To: All Prospective Bidders
Cambridge Redevelopment Authority
GRAND JUNCTION PATH AND PEDESTRIAN IMPROVEMENTS
ALONG GALILEO GALILEI WAY – CONTRACT 16
Cambridge, MA

Re: Addendum No. 1

Date: June 30, 2015

TYPICAL SECTION – CEMENT CONCRETE SIDEWALK
 STA. 10+00± TO STA. 10+69±
 STA. 16+89± TO STA. 17+49±
 SCALE: 1" = 4'

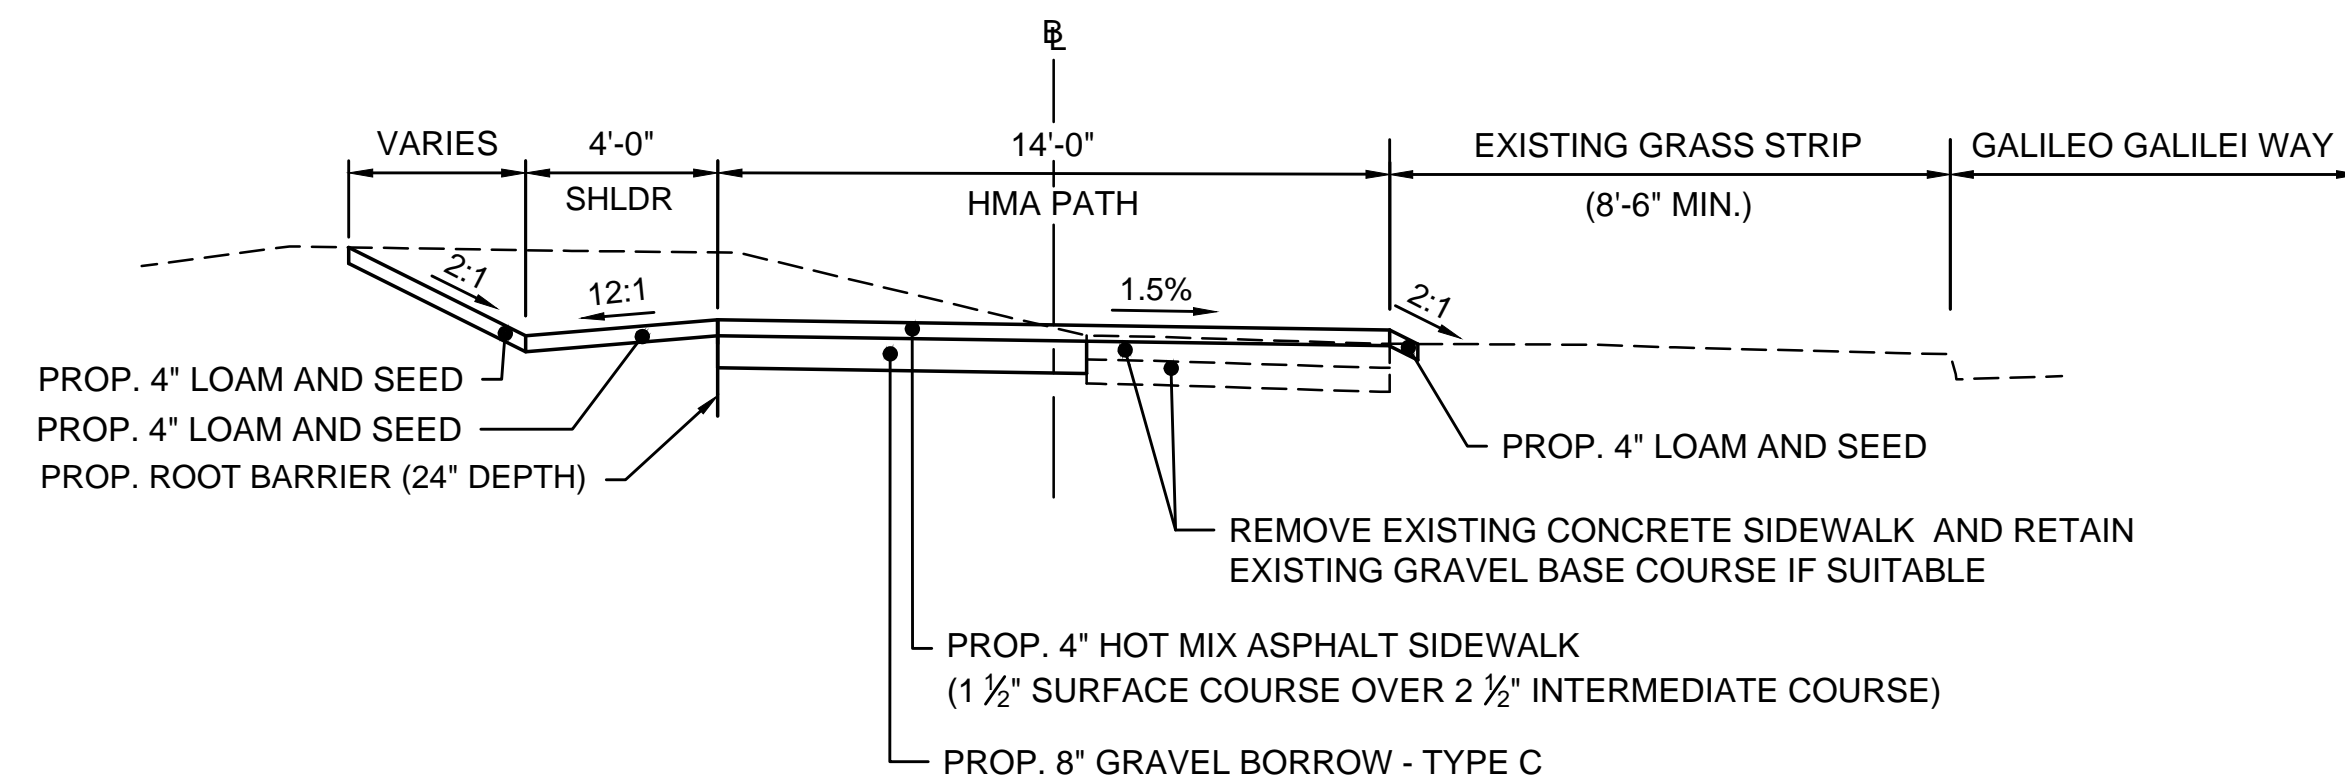
Item 1: Sheet No. C-5, TYPICAL SECTION – CEMENT CONCRETE SIDEWALK:
Change “PROP. GRANITE CURB TYPE VB OR REMOVE AND RESET EXISTING CURB” to “PROP. GRANITE CURB TYPE VA4 OR REMOVE AND RESET EXISTING CURB.”
